DESIGN PH	DRAWN BY PH	DART AEROSPACE LTD HAWKESBURY, ONTARIO, CANADA	
CHECKED 	APPROVED 	DRAWING NO. DSI 9235	REV. B SHEET 1 OF 1
DATE 05.10.14		TITLE QUICK PIN REPLACEMENT	SCALE NTS
A	02.07.03	NEW ISSUE	
B	05.10.14	LENGTHEN QUICK PIN FOR RE-DESIGN

DART SERVICE INSTRUCTION

TO AMEND INSTALLATION INSTRUCTIONS IIN-D206-628 REV. E

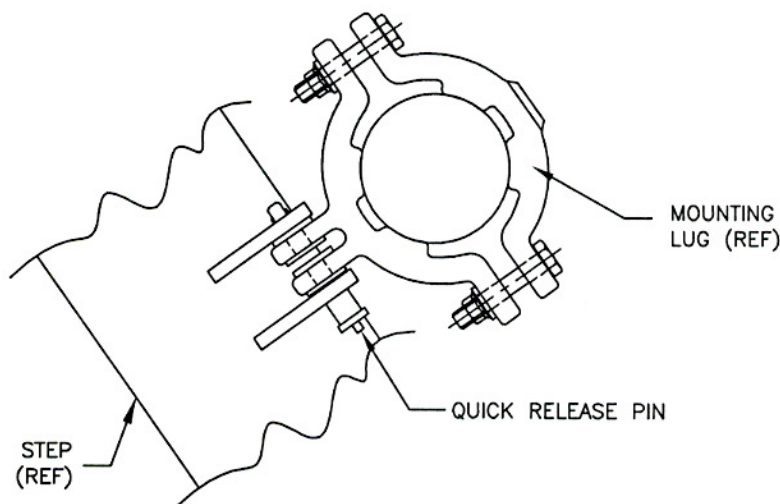
THE FOUR AN4-15A BOLTS USED TO ATTACH THE STEP TO THE MOUNTING LUGS MAY BE REPLACED WITH:

STAINLESS STEEL POSITIVE LOCKING QUICK RELEASE PINS WITH A MINIMUM DOUBLE SHEAR STRENGTH OF 2400 LBS, A 1.3 INCH GRIP LENGTH (MINIMUM), AND 0.25 INCH DIAMETER

BOLT	MINIMUM GRIP	POSSIBLE QUICK RELEASE PIN REPLACEMENT
AN4-15A	1.3" (33.0mm)	AVIBANK: BLC4B13S, BLC4TA13S, BLC4R13S, BLC4LA13S MS NUMBER: MS17984C413, MS17985C413, MS17986C413, MS17987C413 REID: BLRS-020, BLBS-020
